## SAFETY RECALL SERVICE BULLETIN

CP-400-H

CP-400-CA

### Draft hook retaining nut recall (NHTSA recall No. 02E-041) for CP-400-H and CP-400-CA

**FIGURE 3** Manufacturing Date Code location

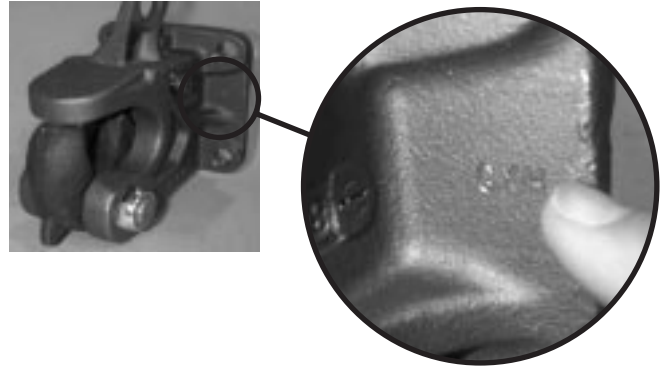
If the coupler has a manufacturing date code listed below (**CHART A**), the coupler **IS** subject to this recall and you **MUST** replace the nut according to the procedure outlined in this service bulletin.

The manufacturing date code is located as shown in **FIGURE 3**.

**FIGURE 8**

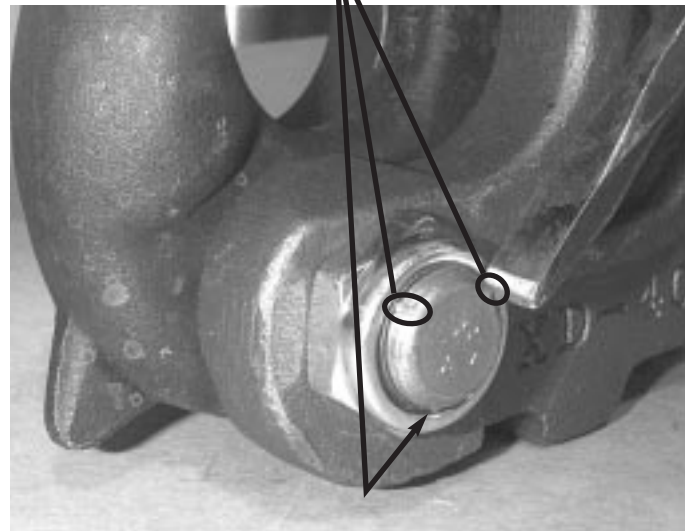
5. Torque the nut to a minimum of 50 ft-lbs. Make sure that the jaw can still rotate freely on the bolt.
6. If you do not have any Loctite you must stake (deform) the exposed threads of the bolt in three places around the bolt, as shown in **FIGURE 8**.

STAKE THE BOLT END
